## I-85/I-385 Interchange Improvement Project

### "Re-Evaluation"

#### 6. DESCRIPTION OF CURRENT PROJECT/DESIGN CHANGES

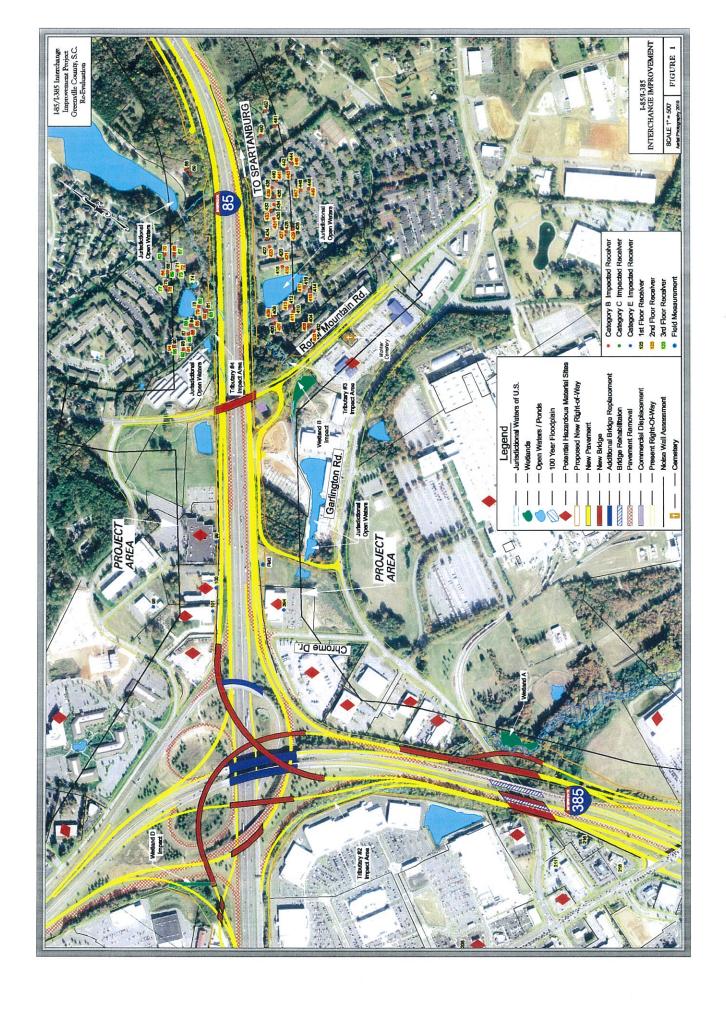
I-85 NB to I-385 NB Ramp Bridge over I-85 (Ramp 3A): This bridge would not be widened or replaced under the currently approved preferred alternative. However, the SCDOT proposes full replacement of this structure. The existing bridge has a width of 33.3' and a length of 299.2' and is comprised of 5 spans; the bridge will be approximately 35 years old in 2015. Based on the current interchange design, the locations of the existing bridge columns and foundations are constricting the space available for the proposed ramps, resulting in shoulder width design exceptions for Ramps 1 and 4A. Additionally, the shoulder widths provided by the existing bridge do not meet current design standards, resulting in a bridge width design exception for Ramp 3A. In order to accommodate the future widening of I-85 to 8 lanes in the vicinity of Ramp 3A, the bridge will have to be replaced.

The proposed replacement bridge is a two-span bridge, 41.3' wide by 356' long. This configuration will accommodate the future 8-lane widening of I-85, provide the desired lane and shoulder widths for Ramp 3A, and eliminate the design exceptions associated with the ramps passing beneath the bridge. The cost is estimated to be \$4.5 million for the bridge replacement and associated roadway work.

**I-385 NB Bridge over I-85**: This bridge would be widened under the currently approved preferred alternative. However, the SCDOT proposes full replacement of this structure. The existing bridge has a width of 50.8' and a length of 665.3' and is comprised of 7 spans; the bridge will be approximately 35 years old in 2015. The existing bridge width is insufficient to provide the desired shoulder widths and auxiliary lane proposed by the current interchange design. The locations of the existing bridge columns are constricting the space available for a proposed ramp beneath the bridge, resulting in a shoulder

width design exception for Ramp 4A. Even if the bridge is widened at this time, the bridge will have to be replaced in the future to accommodate the 8-lane widening of I-85.

The proposed replacement bridge is a four-span bridge, 71.3' wide by 565' long. This configuration will accommodate the future 8-lane widening of I-85, provide the desired shoulder widths and auxiliary lane on the bridge, and eliminate the design exception associated with the ramp passing beneath the bridge. The cost is estimated to be \$11 million for the bridge replacement and associated roadway work.

I-385 SB Bridge over I-85: This bridge would not be widened or replaced under the currently approved preferred alternative. However, the SCDOT proposes full replacement of this structure. The existing bridge has a width of 50.8' and a length of 620.1' and is comprised of 8 spans; the bridge will be approximately 35 years old in 2015. The existing bridge width is insufficient to provide the desired shoulder widths, resulting in a bridge width design exception for I-385 SB. Additionally, the locations of the existing bridge columns are constricting the space available for a proposed ramp beneath the bridge, resulting in a shoulder width design exception for Ramp 4A. In order to accommodate the future widening of I-85 to 8 lanes, the bridge will have to be replaced.

The proposed replacement bridge is a five-span bridge, 61.3' wide by 547' long. This configuration will accommodate the future 8-lane widening of I-85, provide the desired shoulder widths on the bridge, and eliminate the design exception associated with the ramp passing beneath the bridge. The cost is estimated to be \$10 million for the bridge replacement and associated roadway work.

**I-385 NB Bridge over Garlington Road and Railroad**: This bridge would not be widened or replaced under the currently approved preferred alternative. However, the SCDOT proposed rehabilitation of the existing structure to include, but not limited to full depth patching; concrete paving; and bearing rehabilitation. The rehabilitation would improve the existing bridge structure and extend the life of the bridge.

I-385 SB Bridge over Garlington Road and Railroad: This bridge would be widened under the currently approved preferred alternative. However, the SCDOT proposed rehabilitation of the existing structure to include, but not limited to full depth patching; concrete paving; and bearing rehabilitation. The rehabilitation would improve the existing bridge structure and minimize potential design exceptions for I-385 SB.
